Model: Adonis-C4b/c	Date: 26-Sep-05	No.: RB195001a
---------------------	-----------------	----------------

Subject: Firmware Release History (Controller)		Prepared by: K. Takagi	
From: 1st Tech. Support Sec. Service Support Dept.			
Classification:	<input type="checkbox"/> Troubleshooting <input type="checkbox"/> Mechanical <input type="checkbox"/> Paper path <input checked="" type="checkbox"/> Other (      )	<input type="checkbox"/> Part information <input type="checkbox"/> Electrical <input type="checkbox"/> Transmit/receive	<input type="checkbox"/> Action required <input type="checkbox"/> Service manual revision <input type="checkbox"/> Retrofit information

This RTB has been issued to announce the firmware release information for the Controller.

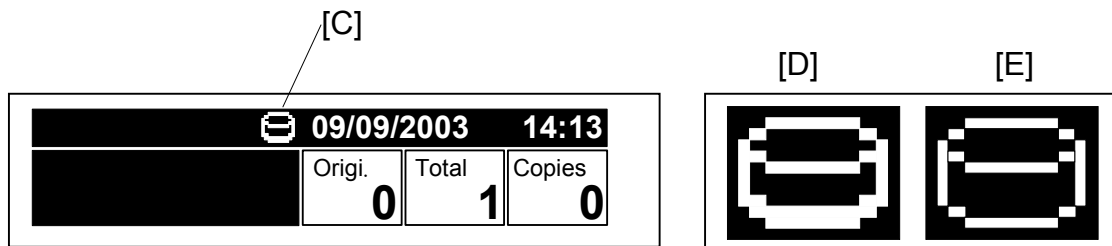
- If the ROM numbers are not the same, or the version numbers are not the same, this means the unit was not installed correctly.

If this happens:

- Make sure the MFP model and unit type match (Type C or D).  
**For this information, see pg. 1 of this RTB.**
- If they do not match:
  - 1) Replace the NV-RAM
  - 2) Replace the "Data Overwrite Security Unit" (SD card) with the correct type
  - 3) Do the installation procedure in this RTB again, from Step 1.

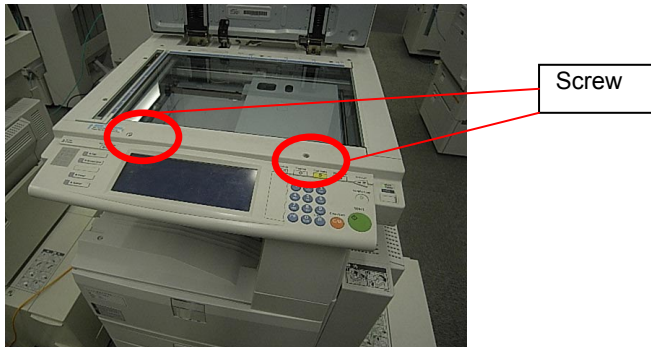
The adhesive was changed to one that will not expand under conditions of standard office environments.

Old Part Number	New Part Number	
B2135222:	<b>H3109900</b>	TOUCH PANEL:HVGA:FU-ACF

## How to distinguish the new parts from the old parts

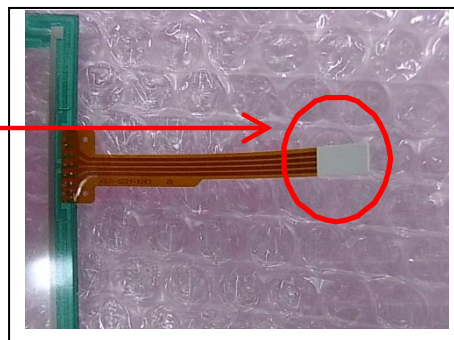
**Old parts:**  
The tip of the electrode is **brown**.

**New parts:**  
The tip of the electrode is **white**.
